Request for Class II Permissive Change

FCC ID: VG8EAM142AYY

Data: 2016-3-1

Original Mother board-top view

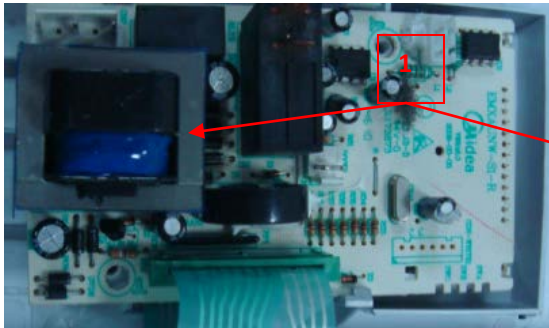
1. Changed Mother -board as below.

Note 1: Changed linear transformer to switching power supply. Between two mother-boards have the same input&output power and the same of circuit function.

Original Mother board -bottom

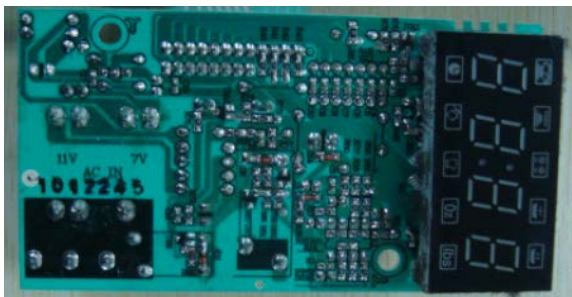
Only differences for component and PCB Layout.

2. Difference for Exterior as below:
Old product:

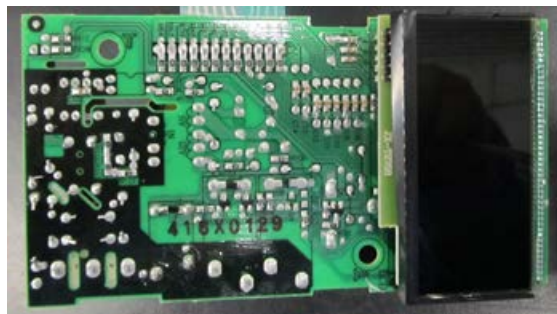
New product removed door-handle.

Rear is basically same as before.
